Initial Submission Review

WINDLER - MIDTOWN PHASE 1 LANDSCAPE & LIGHTING PLANS

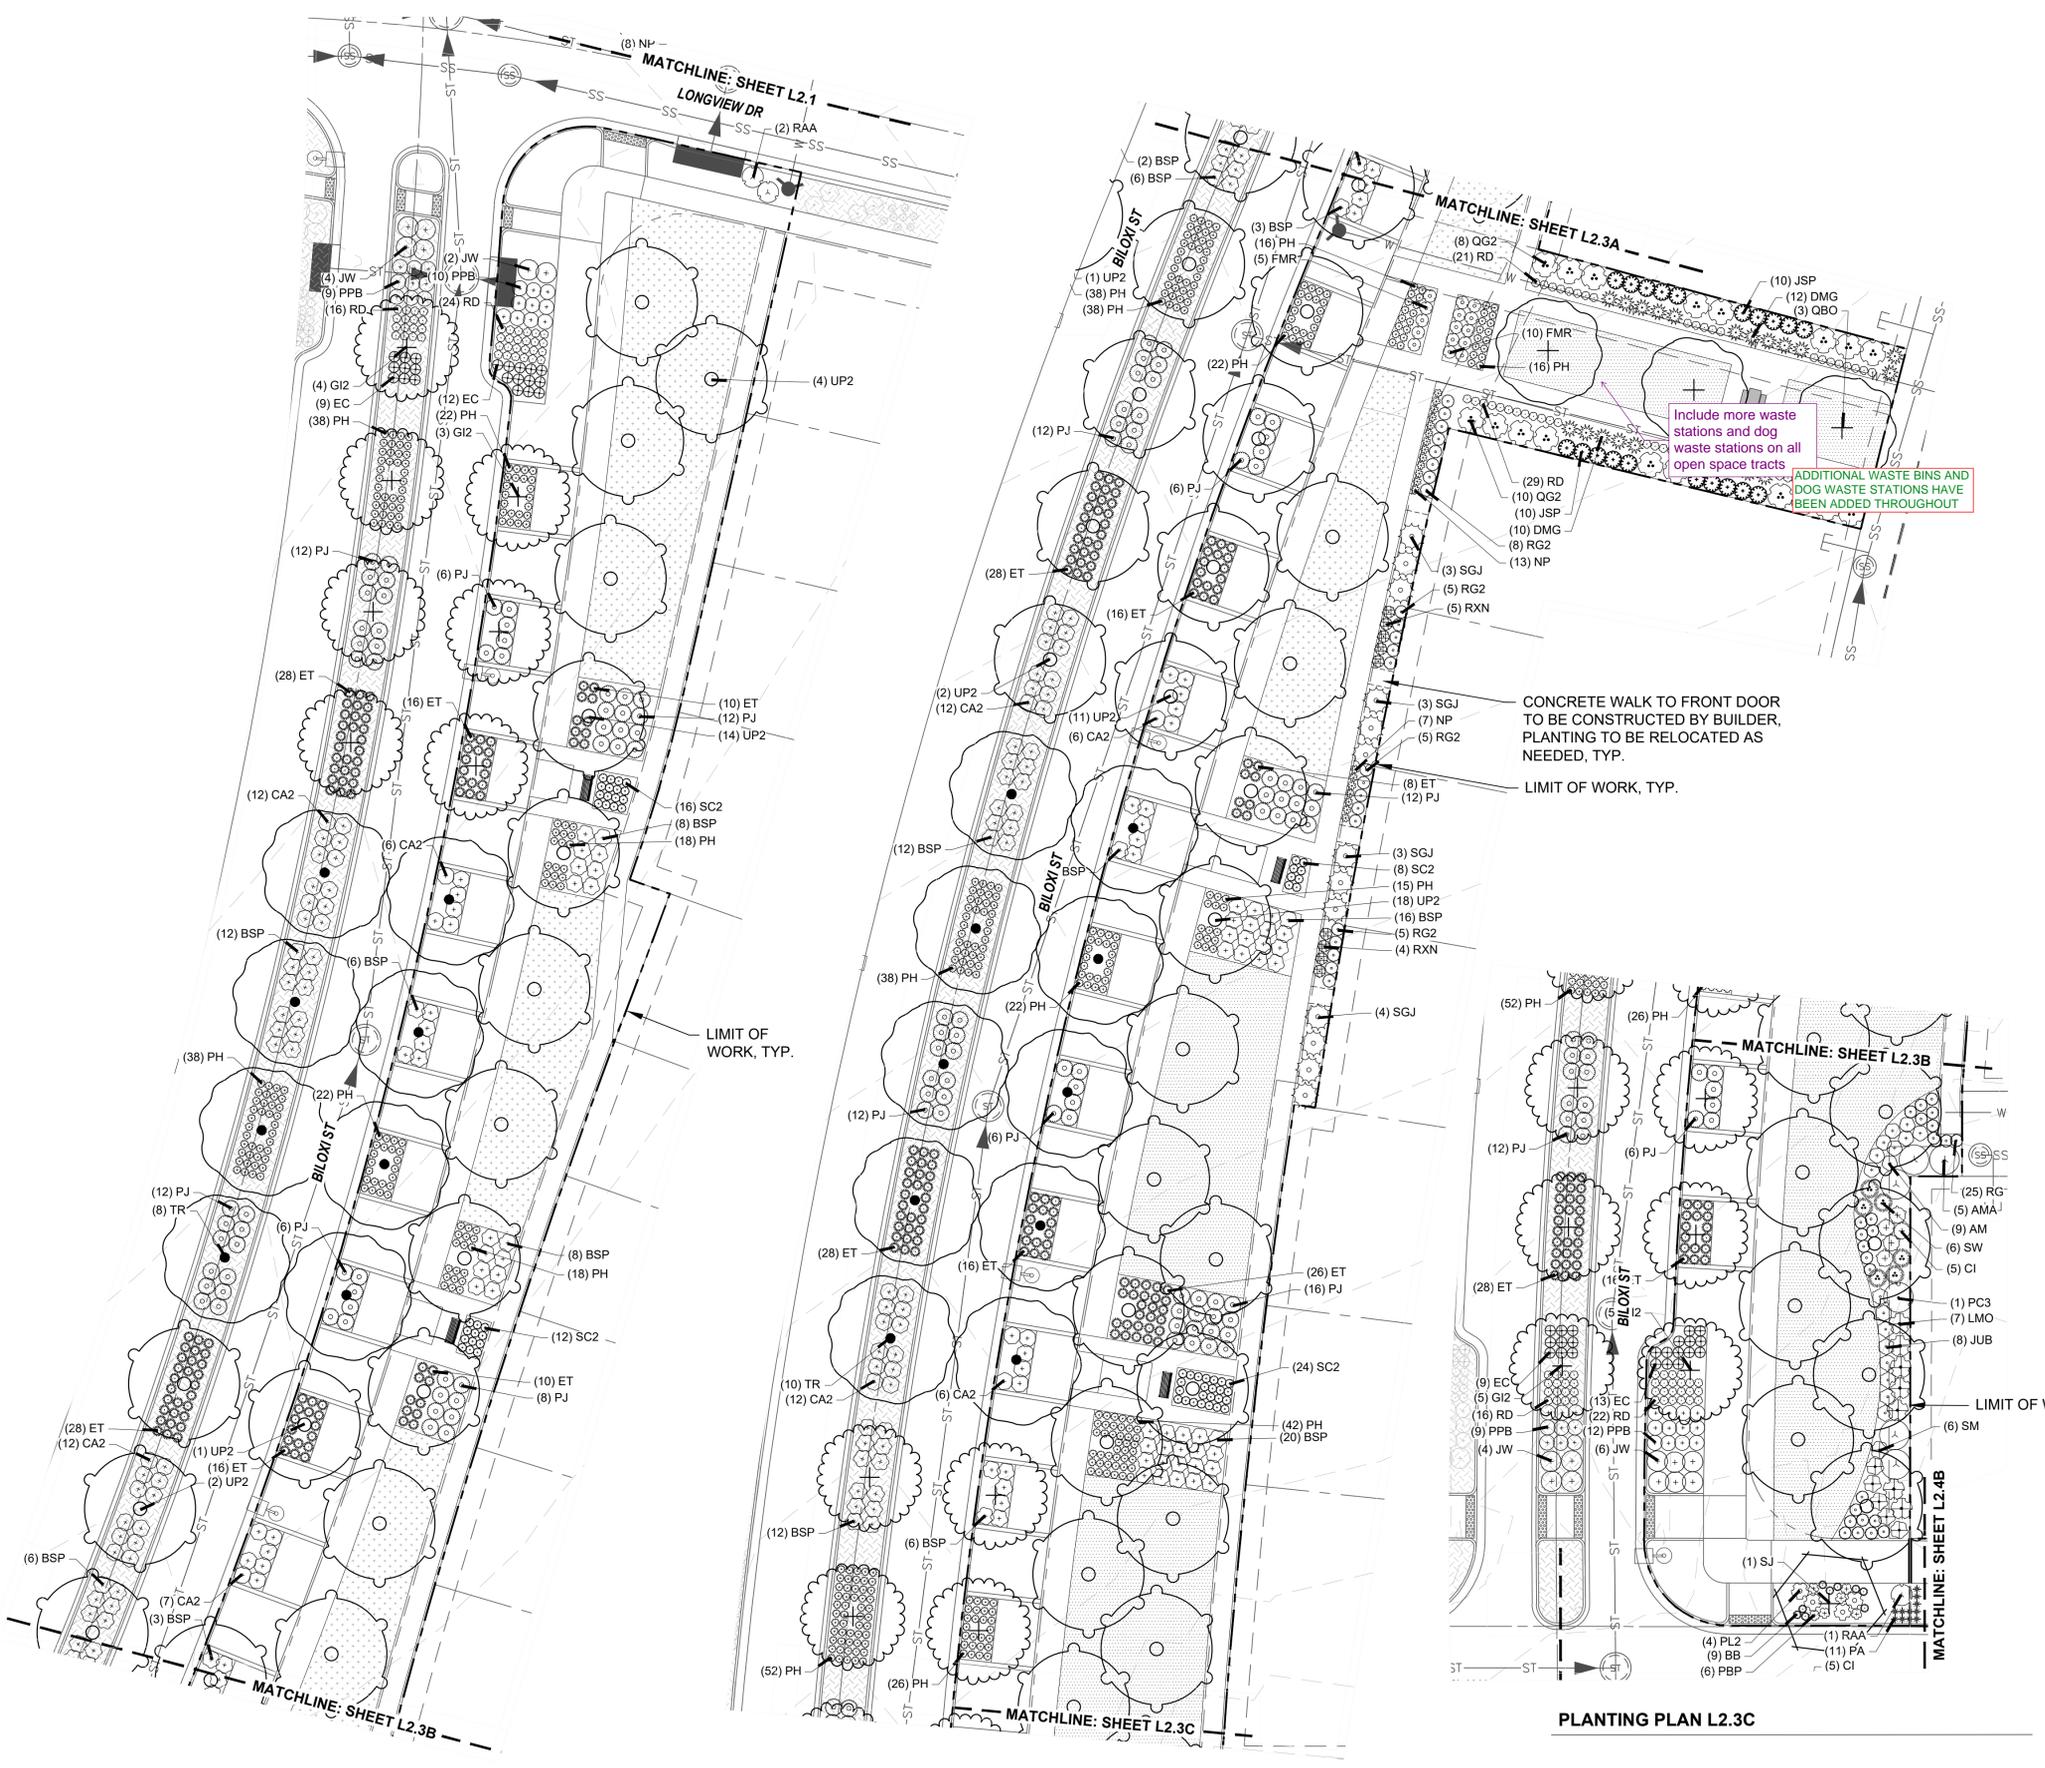
include more amenities

ADDITIONAL AMENITIES HAVE BEEN ADDED THROUGHOUT

3 UMBRELLA TABLE
MANUFACTURER: LANDSCAPE FORMS
PRODUCT NAME: CYGNUS SUN SHADE W/ TABLE MOUNT
NOTE: INSTALL PER MANUFACTURER'S SPECIFICATIONS

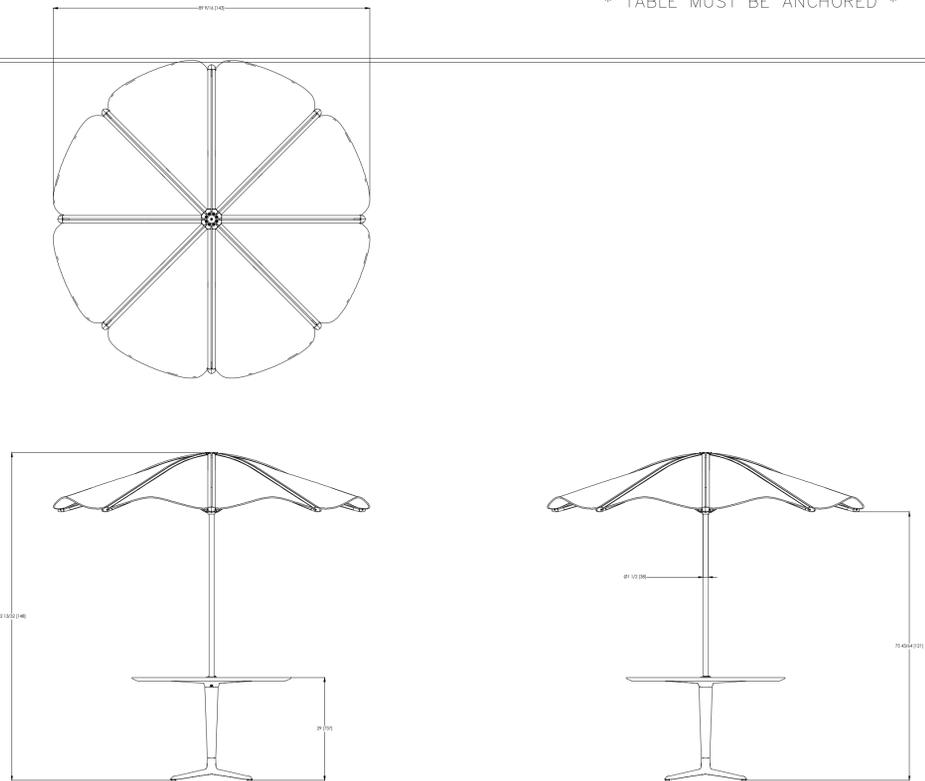
Will Coal bins be included
GRILLS HAVE BEEN REMOVED FROM PLANS

**CURBSIDE
 OVERALL PLAN &
 SHEET INDEX**

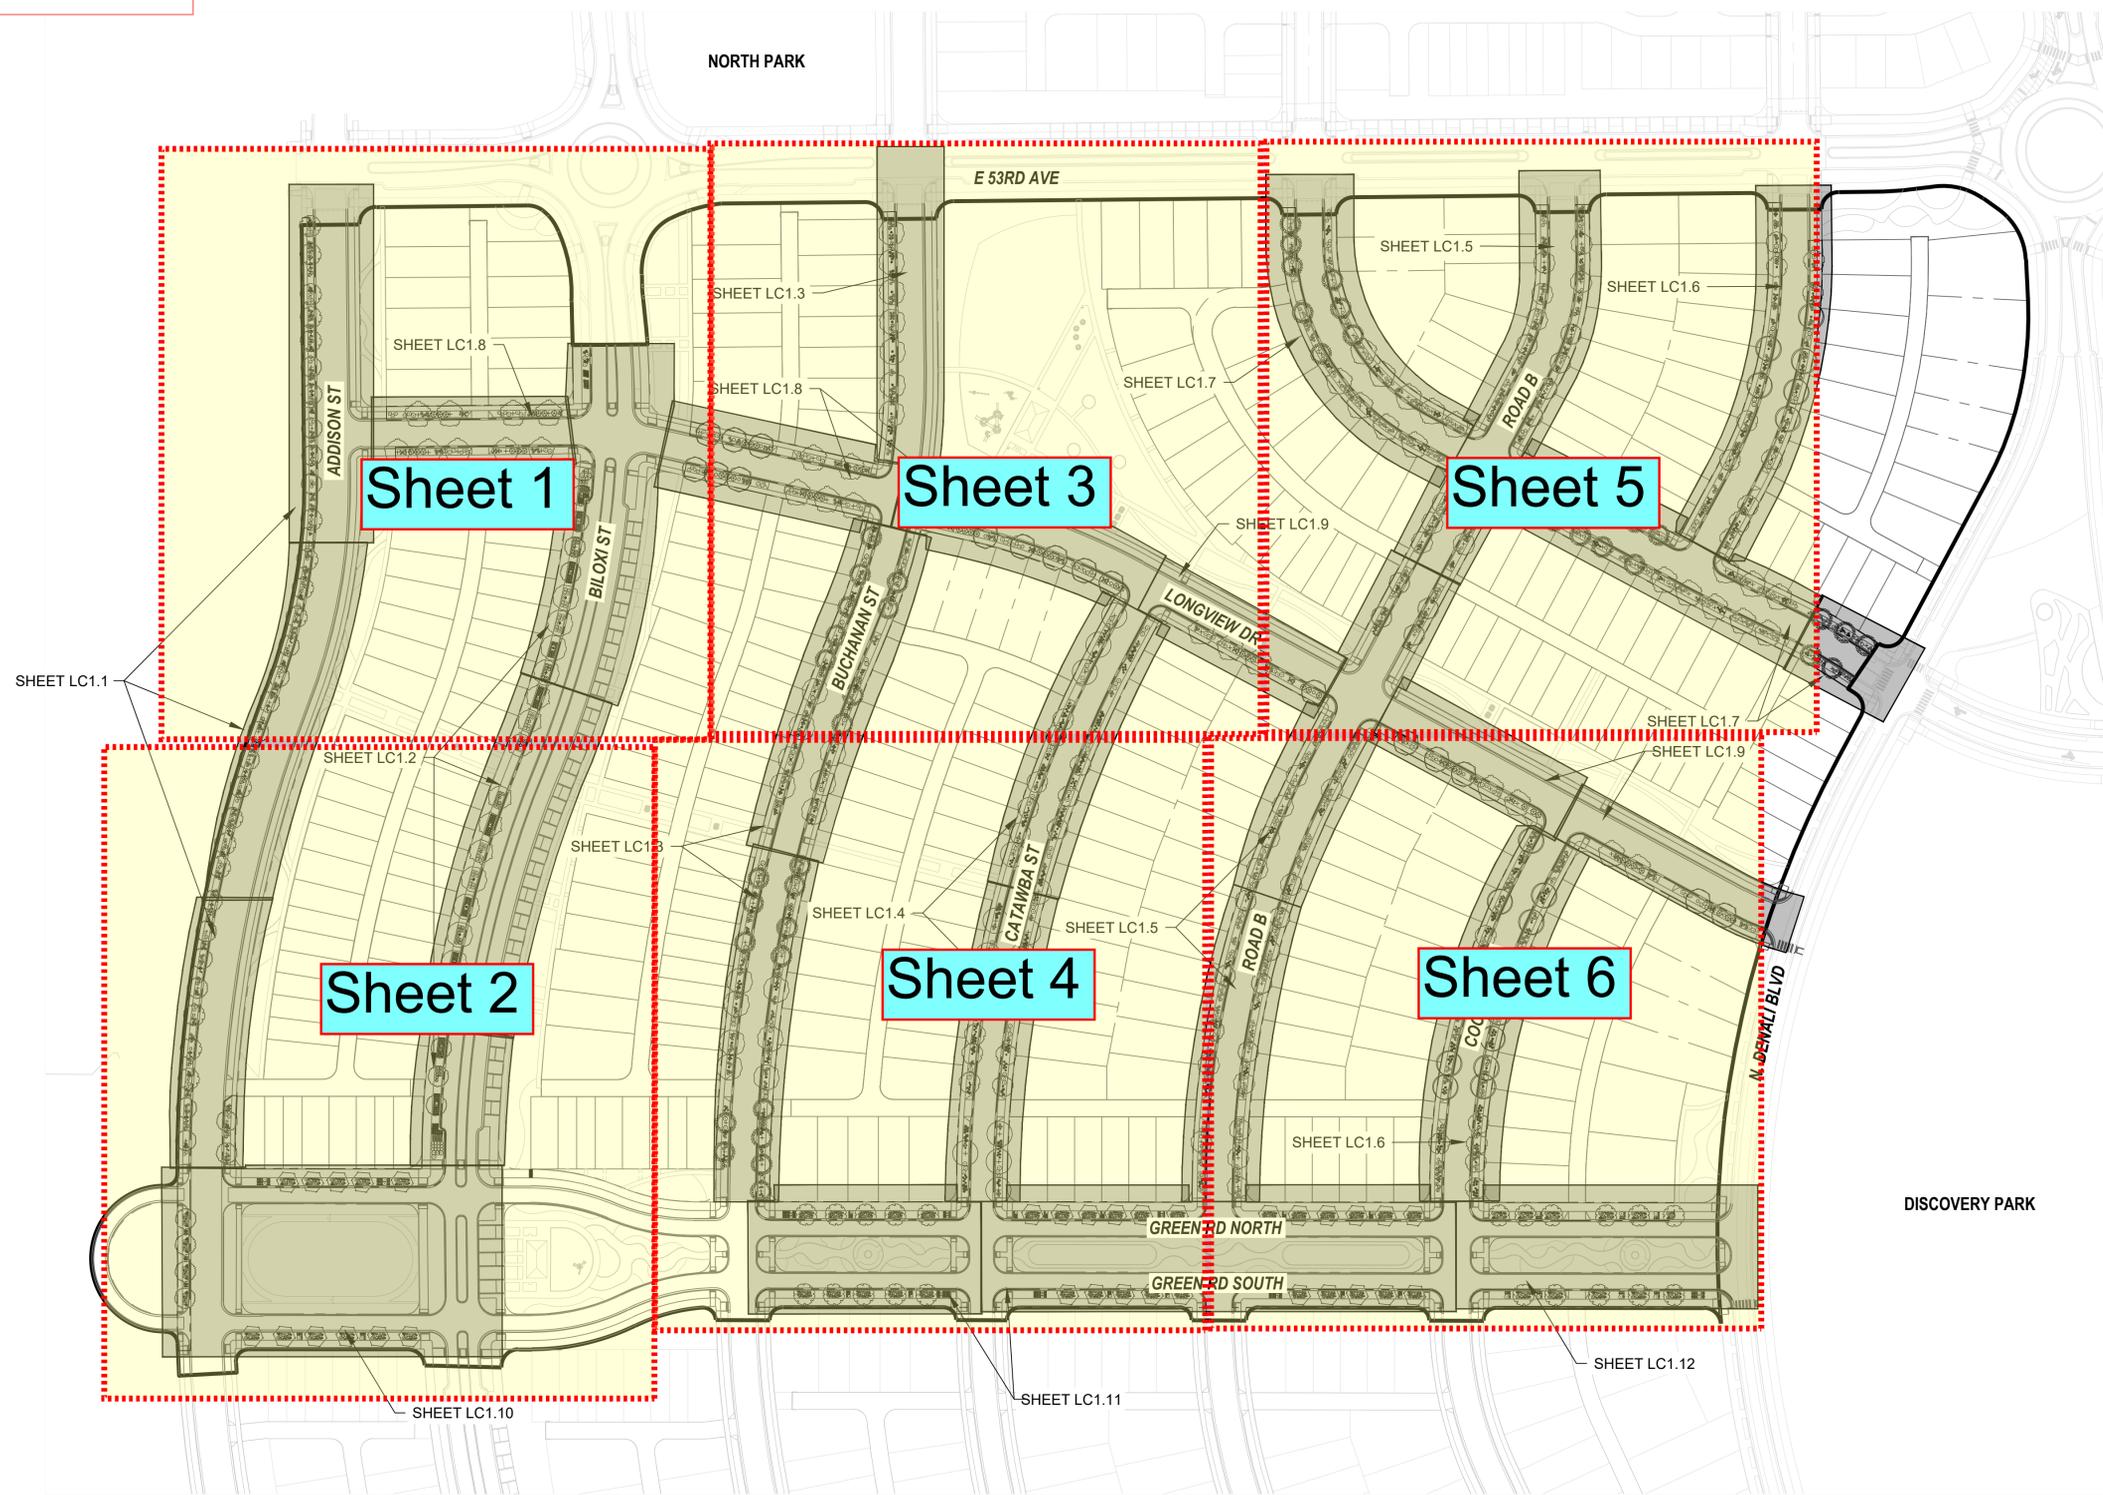
Do not submit a plan with segments of streets for future submittals. Break the site up into sheets with matchlines as demonstrated below. Having little street segments makes the review process of the curbside landscaping and street trees difficult and not efficient for planning staff.

REVISED AS REQUESTED
